CITY OF
**PALO
ALTO**

Architectural Review Board Staff Report

Meeting Date: April 6, 2023
Report #: 2303-1194

3300 El Camino Real [21PLN-00028]: Ad-Hoc Committee Review of Previously Approved Project to Review Architectural and Landscape Element Design Changes

10/20 Submittal

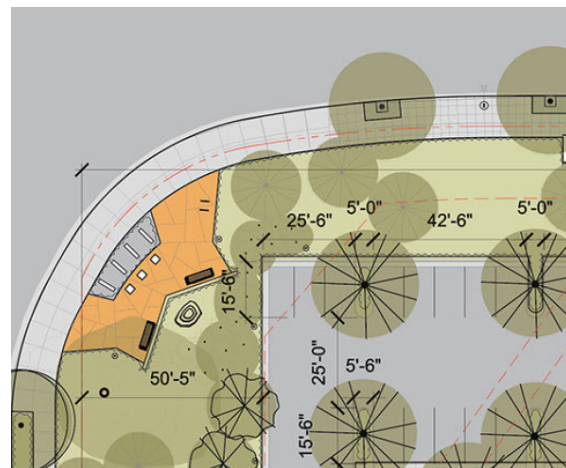
A. Enhanced Landscape on El Camino Real Frontage

The ARB recommended that the applicant enhance their landscape plan along the El Camino Real Frontage to incorporate a linear park to activate the street and better respond to El Camino Real Design Guideline 2.3.1.2 and 3.2.5.

The applicant has expanded the size of the corner pedestrian plaza at Hansen Way and El Camino Real and added fixtures to attract pedestrians to use the space. However, to create a linear park, staff would suggest the applicant add a decomposed granite (DG) walkway from the corner plaza to the front entrance plazas. The applicant has stated this is infeasible.

See the attached drawings for refinements to the landscape strip design along El Camino Real.

10/20 Submittal

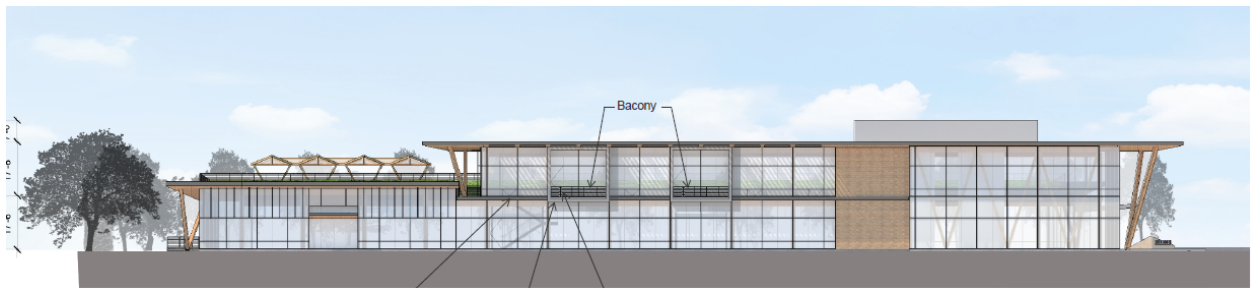
B. Consider Adding Texture to El Camino Real Façade

The ARB recommended that the applicant modify their existing façade on El Camino Real to incorporate additional textures to add additional articulation to the street facing side of the building.

See the attached drawings for the proposed changes to the façade facing El Camino Real. Two new framed balconies are proposed on the second floor that provide for greater articulation and visual texture to the façade.

The applicant has provided the requested modifications.

4/6 Submittal

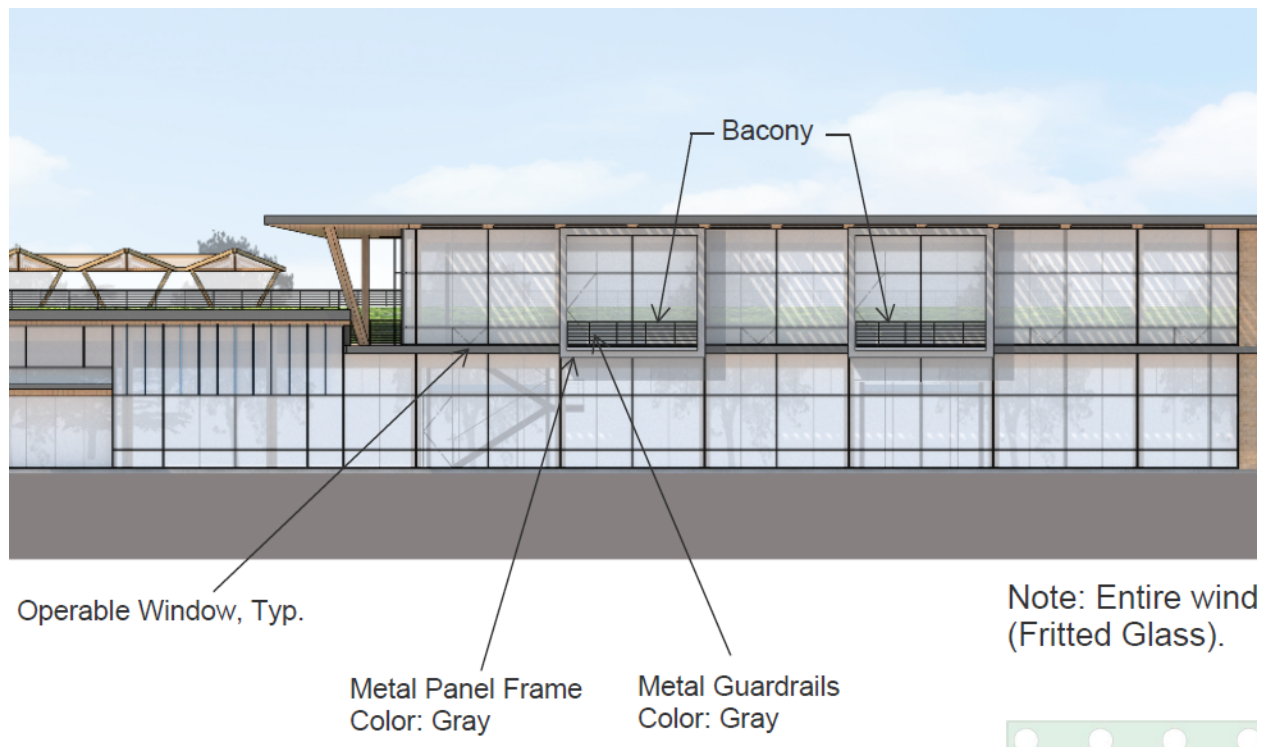
D. Add Operable Windows to the Building

The ARB recommended that the applicant incorporate operable windows into the design of their building.

The applicant has provided the requested windows on the El Camino Real façade. There does not appear to be any added windows on other façades.

See attached drawings for the proposed locations of the added operable windows on the second floor along the El Camino Real façade.
